CCO #42 Review Comments
By
Sandy Michelotti & Michael Travis
March 21, 2008

SAS SUPERSTRUCTURE ROADWAY WESTBOUND
LIGHTING AND ELECTRICAL SYSTEMS

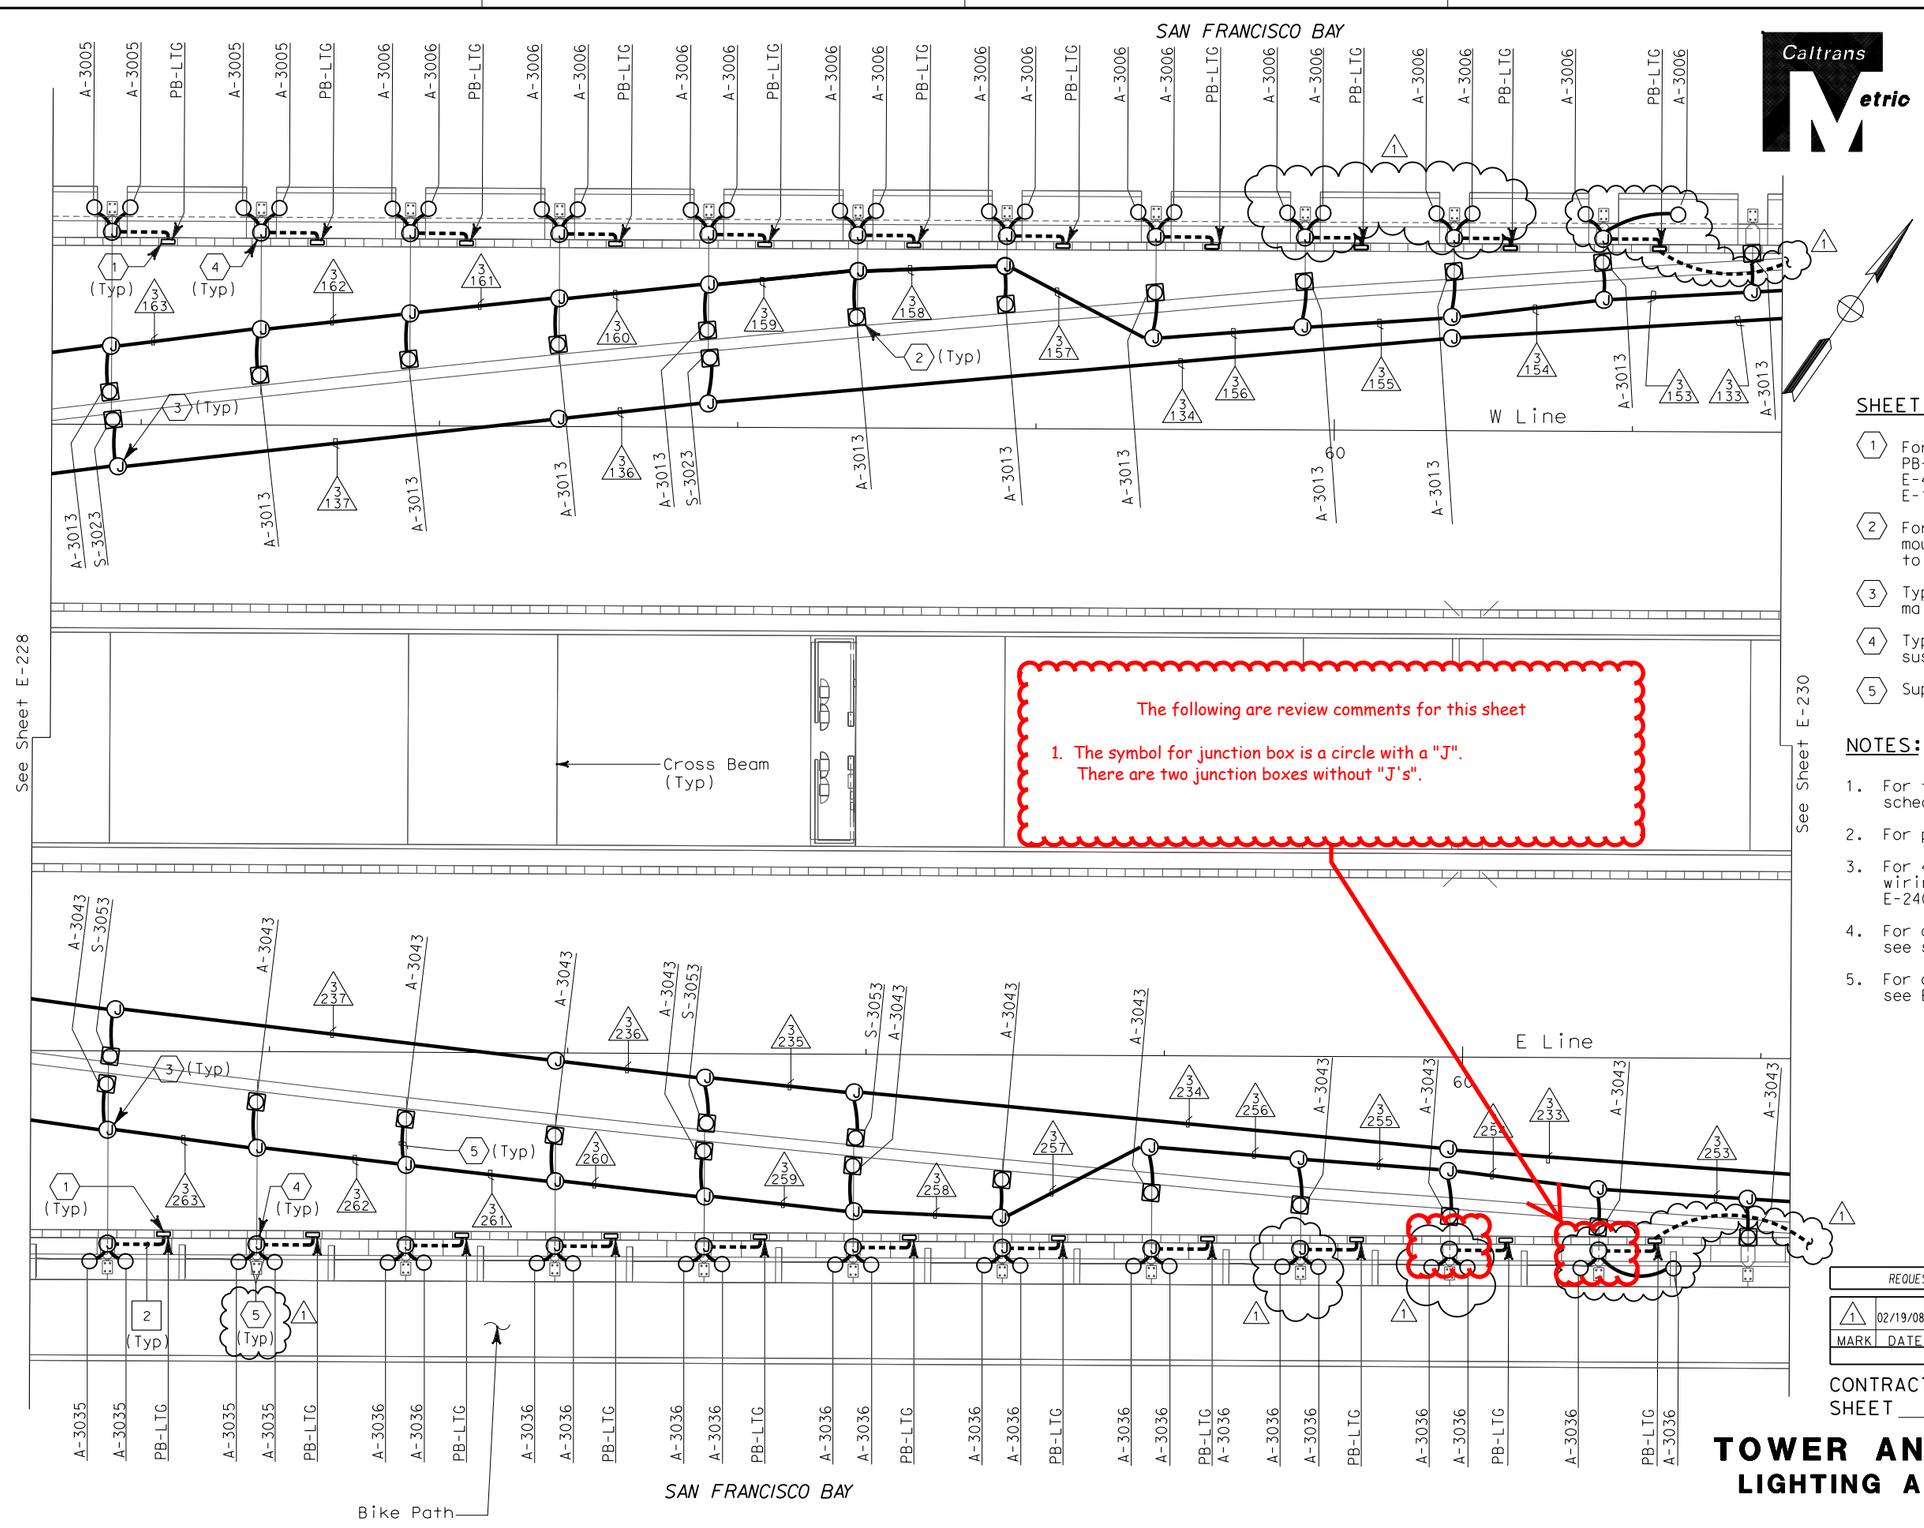
1. The symbol for junction box is a circle with a "J". There are two junction boxes without "J's".

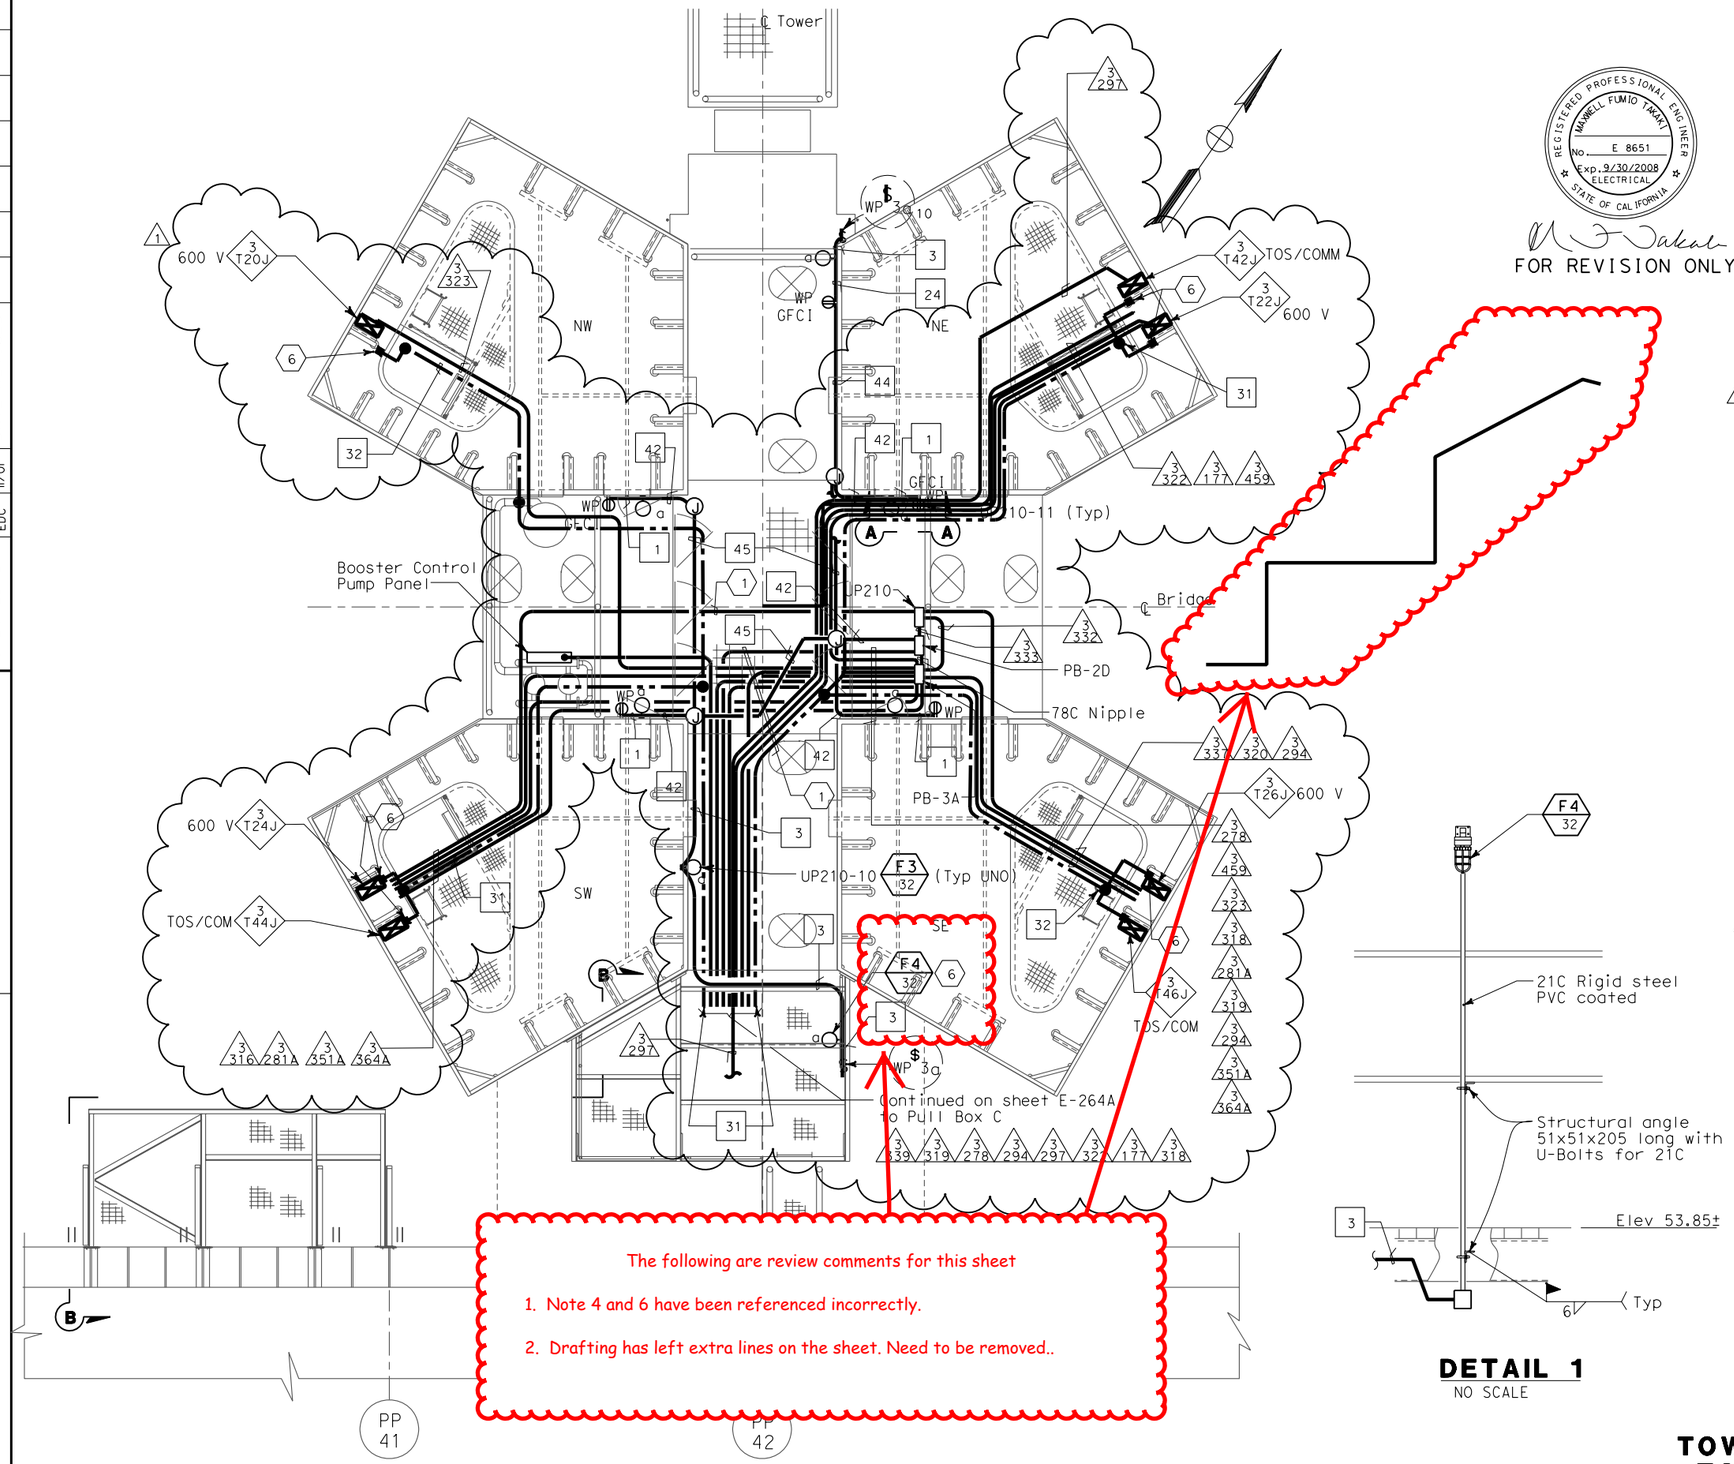
1. Note 4 and 6 have been referenced incorrectly.
2. Drafting has left extra lines on the sheet. Need to be removed..

DEHUMIDIFICATION UNIT #2 PLAN- AT ELEV. 9.0 m

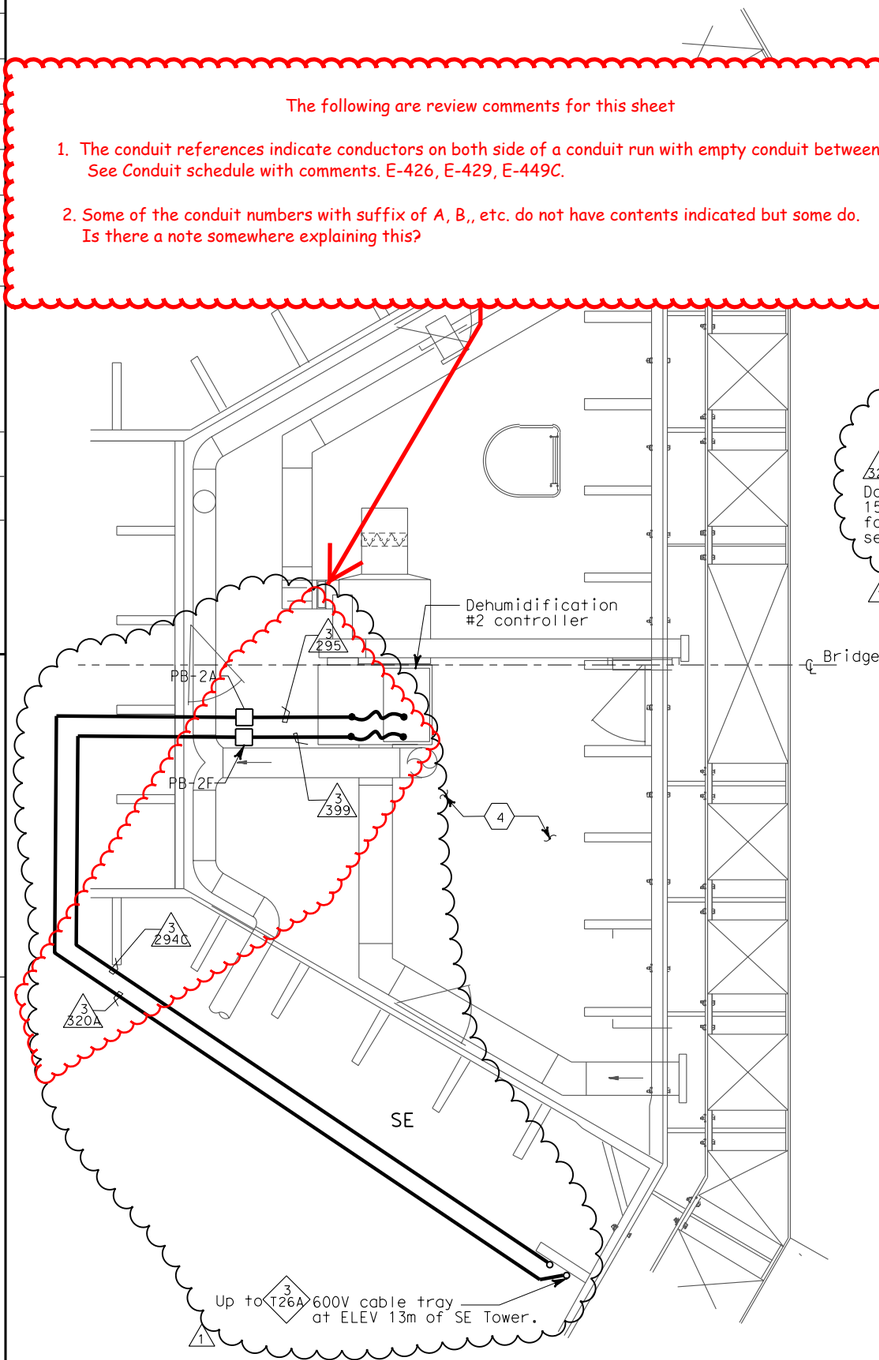
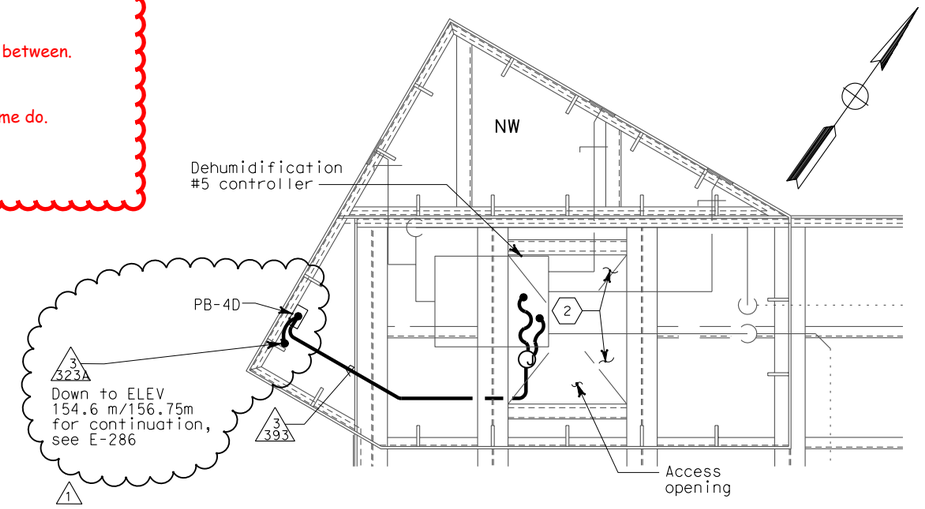
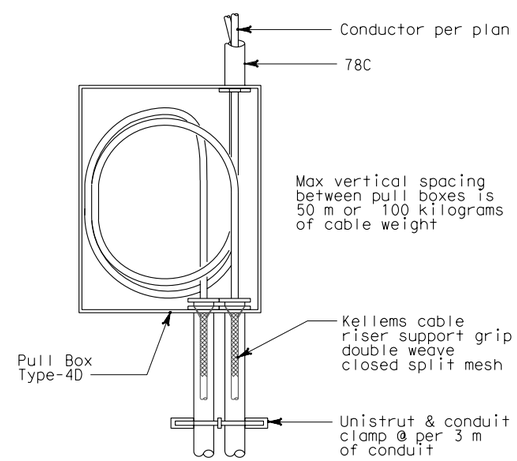
1. The conduit references indicate conductors on both side of a conduit run with empty conduit between. See Conduit schedule with comments. E-426, E-429, E-449C.

2. Some of the conduit numbers with suffix of A, B,, etc. do not have contents indicated but some do. Is there a note somewhere explaining this?
